# **INDIANA DEPARTMENT OF TRANSPORTATION**

## **Design Memorandum No. 21-01**

**SUBJECT:** Longitudinal Joint Options and D-1 Contraction Joint Spacing

**REVISES:** *Indiana Design Manual (IDM) Figure 602-3Z, Median Edge Concrete Pavement Longitudinal Joint Options*

Figure 602-3Z

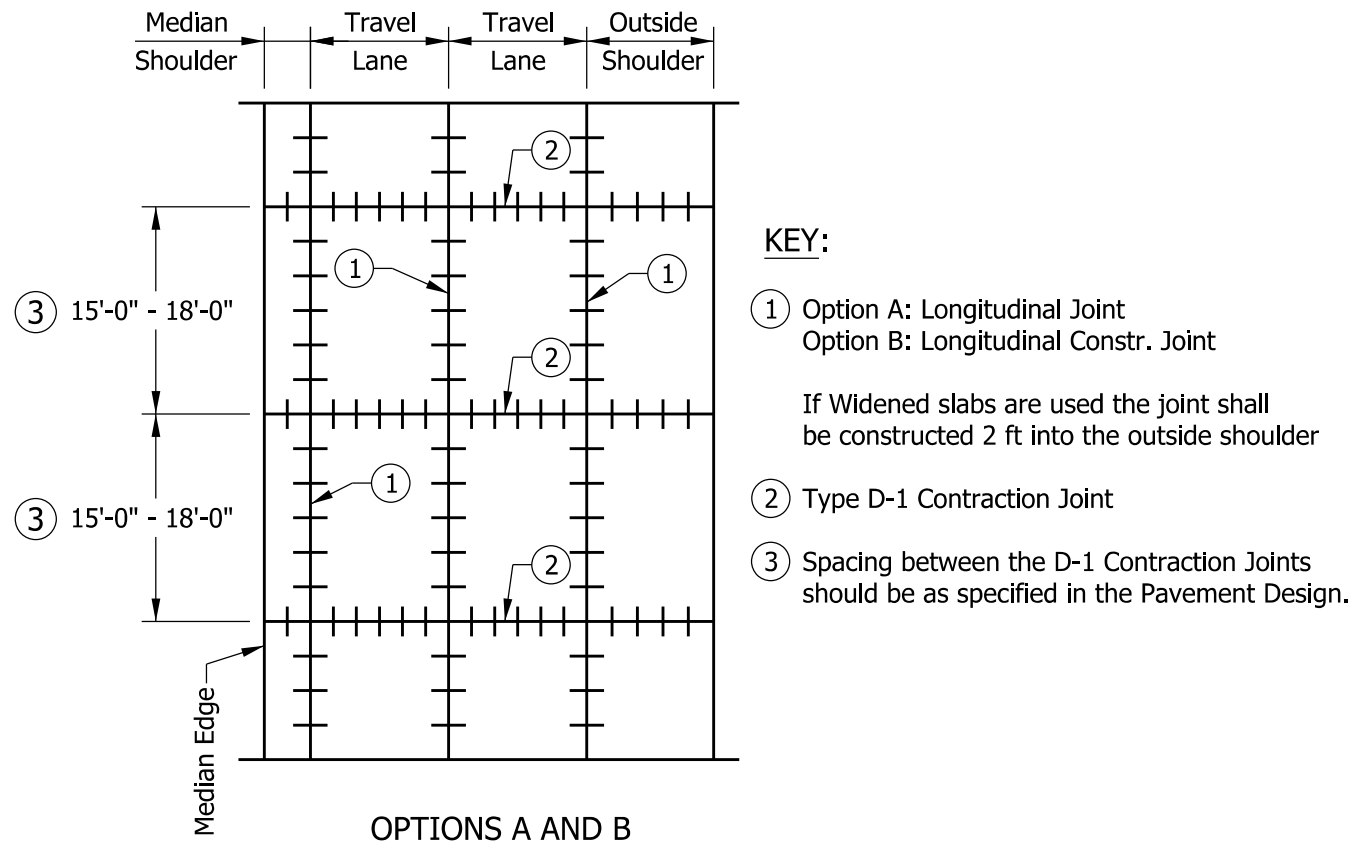
The following revisions were made to Figure 602-3Z:

- Legend note numbers on the figure were reassigned to reflect the longitudinal joint options for the contractor and longitudinal joint locations.
- Note 3 was added to clarify that D-1 contraction joint spacing should be designed as directed by the pavement design.
- The figure was renamed to Longitudinal Joint Options and D-1 Contraction Joint Spacing.
